PB ASSOCIATES

POWERLINK REVENUE RESET

Response on Selected Issues in Powerlink's Submission

Figure 2.6: Age profile of Powerlink's network assets

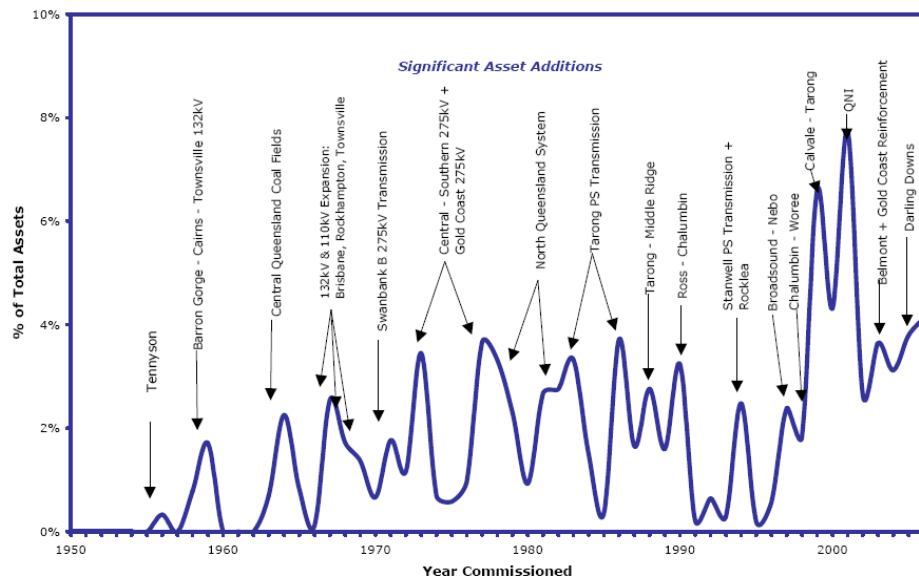
Our analysis has assumed that assets were added to the network at a constant rate over the period 1955-1998, which is not inconsistent with the age profile provided in Figure 2.6 of Powerlink's revenue application and reproduced below. We note that the bulk of the value of Powerlink's asset base is in primary assets, namely lines and substations, which have assumed economic lives of 50 and 40 years respectively. This would indicate that only lines constructed before 1962 and substations constructed before 1972 should need to be replaced by the end of the current regulatory period. Given that the bulk of the assets under consideration were commissioned between 1972 and 1990 a more accurate analysis is likely to reduce the indicated asset replacement requirement.

Figure 3.1: Post contingent flows on critical line Scenario 9.6 and 33.6 for the Strathmore-Ross development.

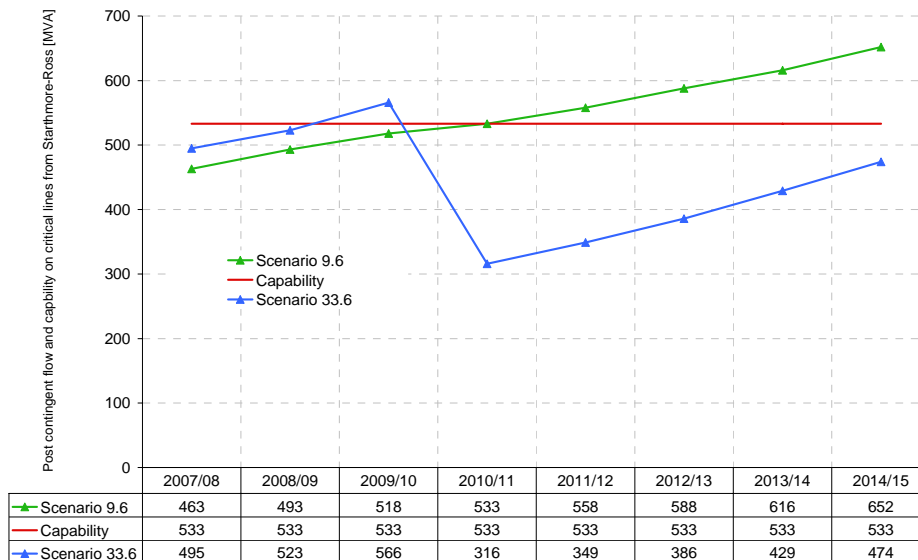
With respect to the Strathmore-Ross project, and as an example of Powerlink's approach to the risk based acceptance of potentially exceeding its mandated reliability obligations, for Scenario 9.3 and 33.3 in the following Table 3.1 of thermal limitations it can be seen that >10% overloads (viz. potentially >583MVA flows on a 530MVA rated piece of plant) during summer 2010/11 and 2008/09 were acknowledged and accepted, respectively. Powerlink has argued that a potential 10% overload in one sub-scenario is acceptable whereas an average overload of 7% on six sub-scenarios is not. While this is a valid argument, the basis for PB's recommendation of deferral in the high growth scenario

(33.6) is the fact that the constraint is removed in the following 5 years by the modelled development of new generation (depicted in Figure 3.1 as the large drop in loading on the blue curve). This generator is still assumed to proceed (even without the PNG gas pipeline) for the high growth scenario – on this basis we maintain our original recommendation to defer the project in the four high load growth scenarios, whilst accepting a marginally higher level of risk than that which would have existed otherwise.

Regarding the Strathmore-Ross project, Powerlink's comments in section 5.2 of its response to PB's draft report on the supplementary revenue proposal is relevant to our final recommendations. In this case the updated and increased demand forecasts considered in Powerlink's supplementary revenue proposal do advance the need for augmentation and the materiality of the risk of constraints should the project be deferred. However, in our view, the identified consequences of the update in demand forecasts for the high growth scenario are countered by the fact that the underlying generation development is also likely to be advanced as a result of the increased demand. On this basis, we consider the two year exposure identified is very much a worst case scenario and is likely to be attenuated to acceptable levels given the correlation between the generation planting and demand forecasts. On this basis we further maintain that the project is not required until around 2014/15 under the high growth scenario 33.6 (which is effectively the same time as it was required under the original forecasts).

Figure 4.1 - Comparison of Loss of Supply events > 0.2 system minutes

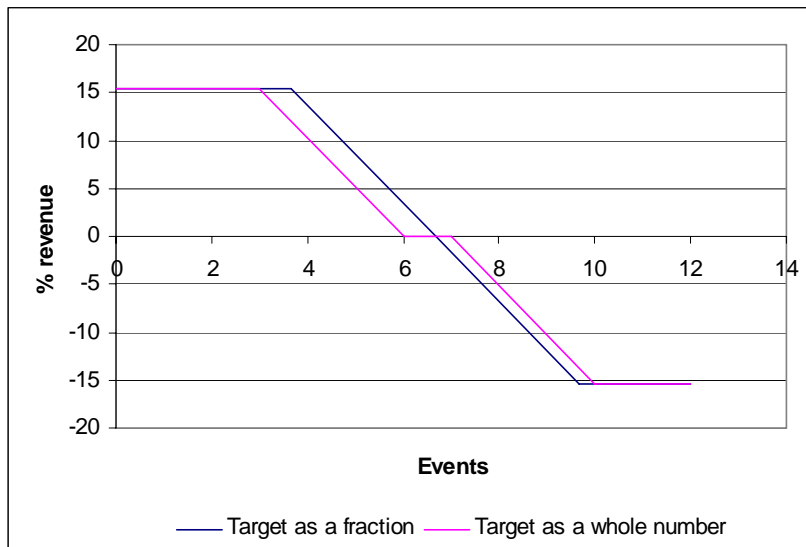
PB considers that this approach—rounding to whole numbers in conjunction with dead bands between whole numbers—reduces the sharpness of the scheme as demonstrated in Figure 4.1 and Figure 4.2⁹. The figures show that penalties and rewards are reduced (for events within the collar and cap) when compared to the scheme recommended in the PB Review.

For the loss of supply >0.2 system minutes, the potential reduction in penalties is equivalent to \$100,000 pa and the reduction in rewards is equivalent to \$210,000 pa, representing 11% and 22% of the value of the measure within the incentive scheme. For the loss of supply >1.0 system minutes the potential reduction in penalties is equivalent to \$60,000 pa (3%), based on the collars, caps and weightings contained in Powerlink's submission on the AER's draft decision.

Figure 4.2 - Comparison of Loss of Supply events > 1.0 system minutes

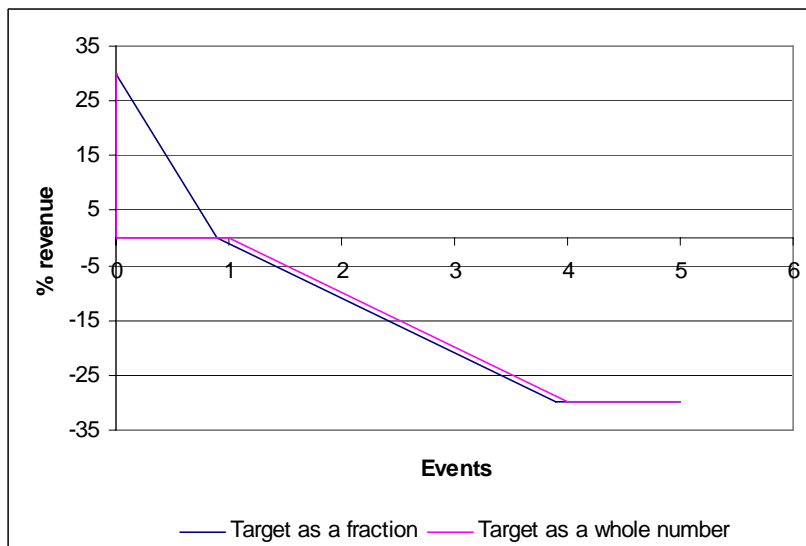
Because the reduction in rewards is different from the reduction in penalties (if the target performance is not a multiple of 0.5), a small asymmetry is also introduced into the scheme, which does not support a neutral revenue outcome for no change in underlying performance across the 5-year regulatory period. For the loss of supply >0.2 system minutes, the asymmetry is equivalent to \$110,000 per annum and for the loss of supply >1.0 system minutes is equivalent to \$60,000 per annum, based on the collars, caps and weightings contained in Powerlink's submission on the AER's draft decision.
